ADDRESS OF PROPERTY: 621 East Tremont Avenue, *Dilworth Local Historic District* *HDC 2013-068*

SUMMARY OF REQUEST: Second-story Addition

Staff Analysis

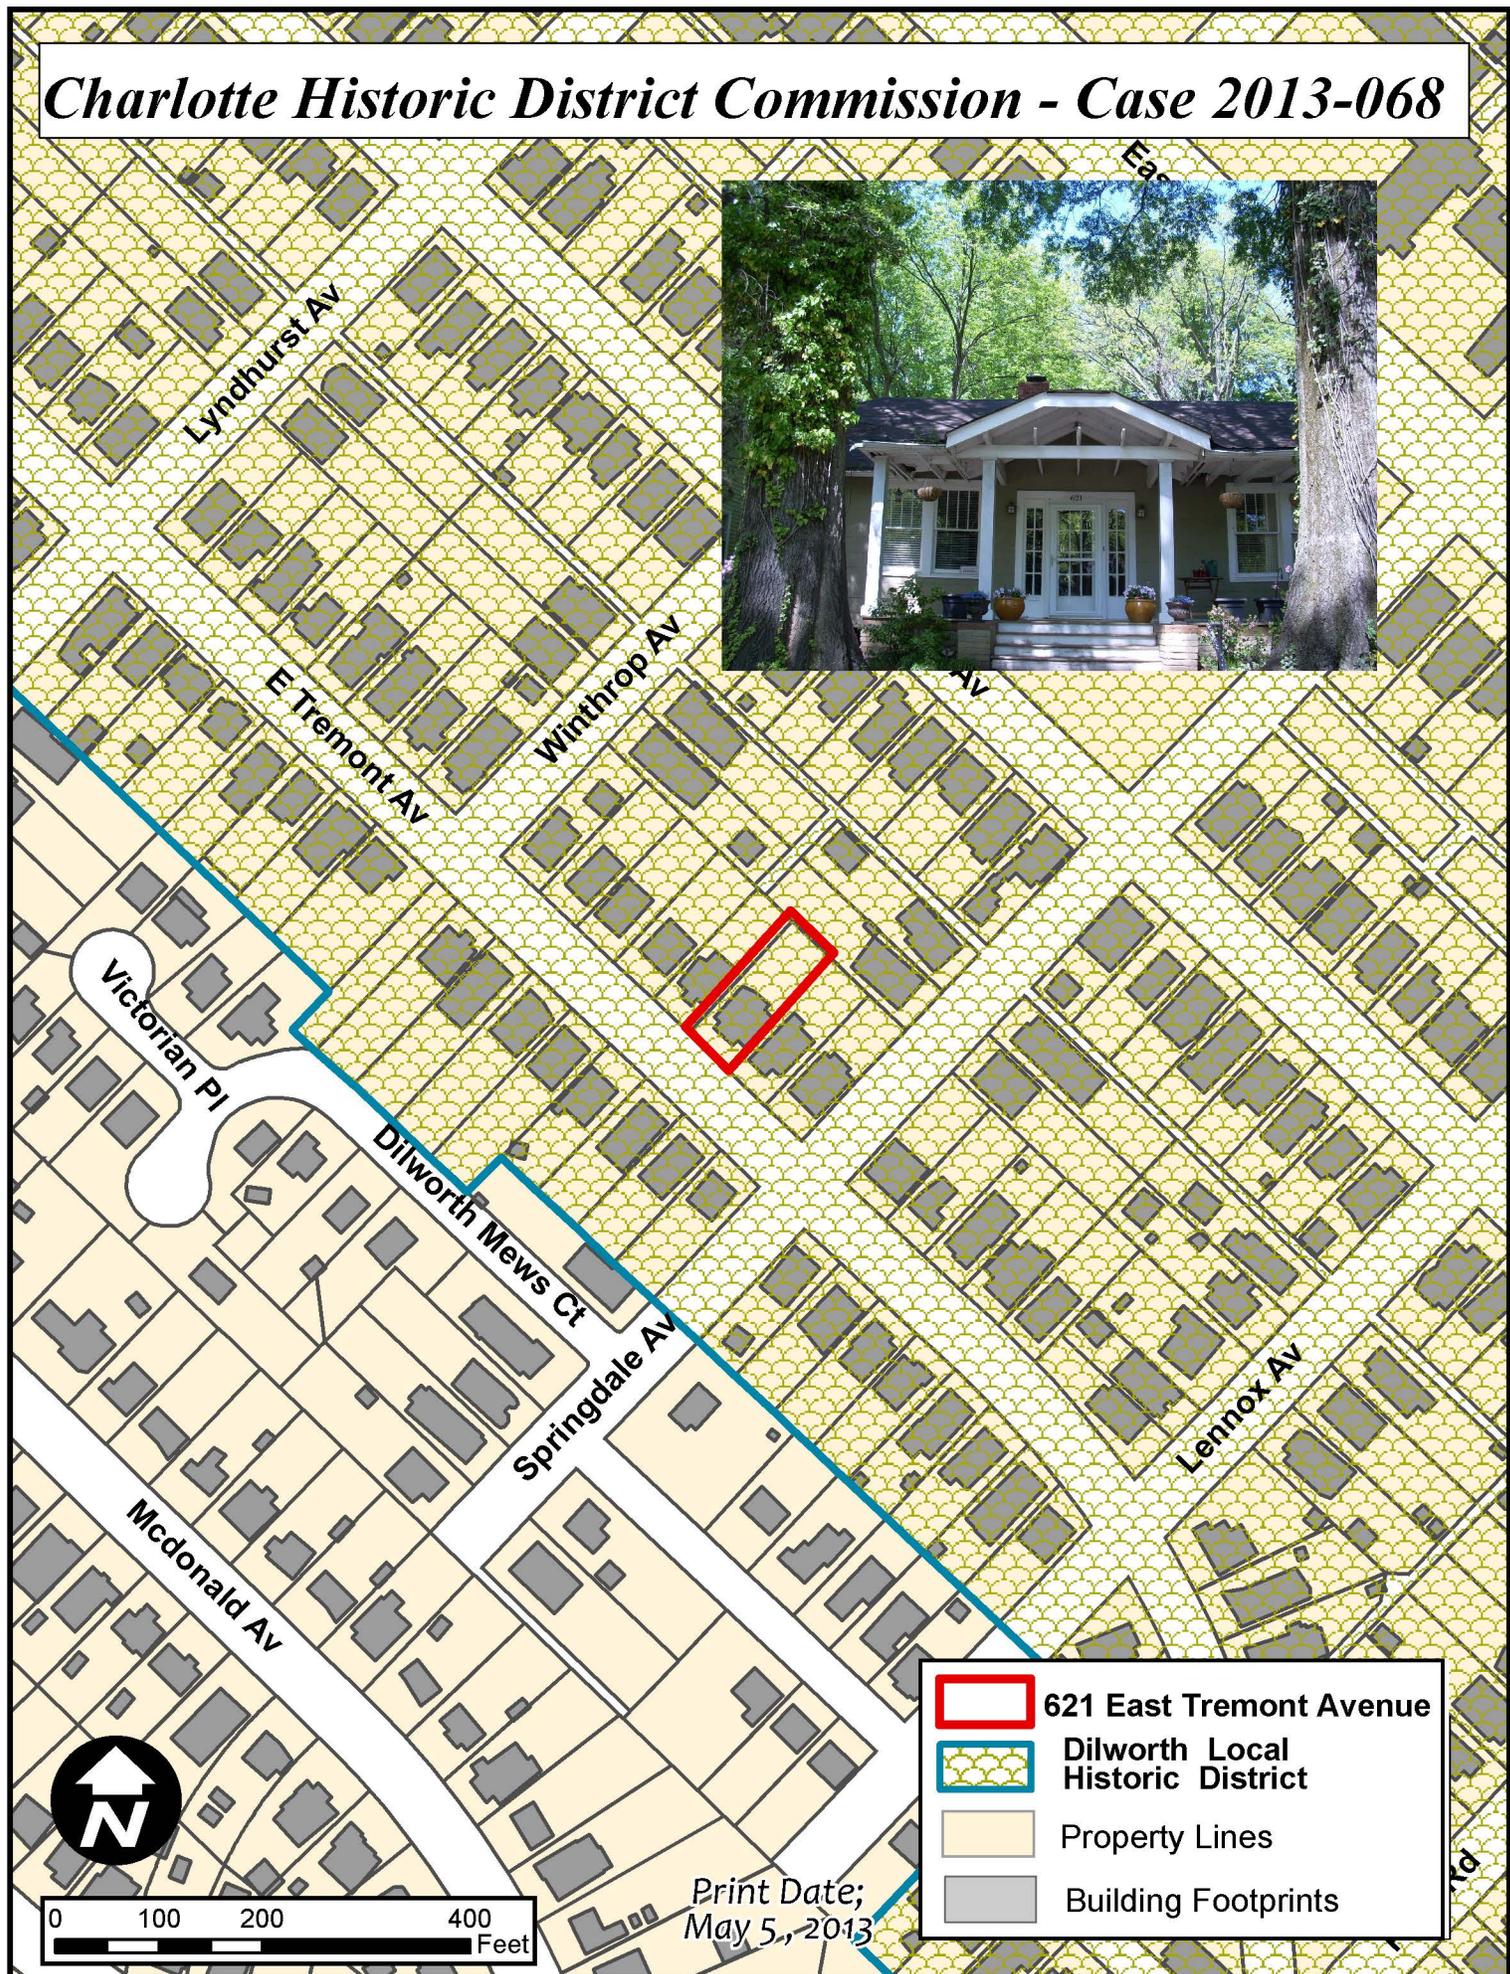
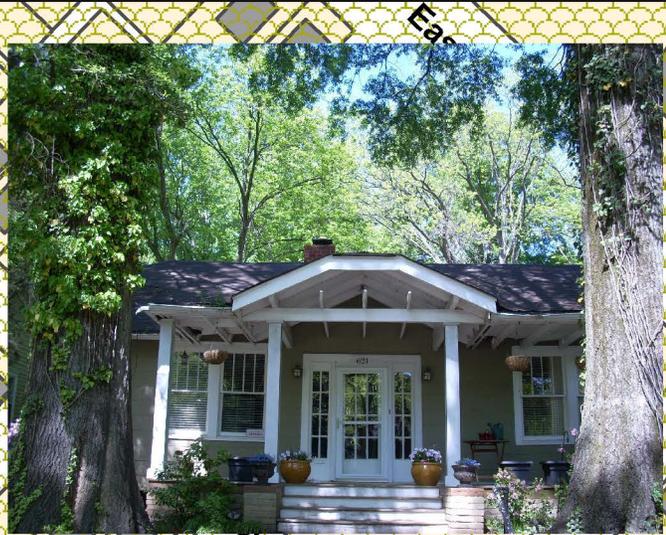
This is a c. 1915 house that is located mid-block on Tremont. It is one story and to be completely transformed by adding a second story. New elements include two steep gables on the front – one for the second floor and the other as an entry element with a swoop on one side. A shed dormer will be added to side of new primary front facing gable. Many new design elements and new materials will be introduced. The Commission Deferred the application due lack of sufficient information regarding the context of the street and the immediate context. Also an approvable application would be a little more modest.

Though materials and details and style elements shown are appropriate to several of the Local Historic Districts, it will be up to the Commission to determine if THIS transformation is appropriate to this particular location and to this particular house.
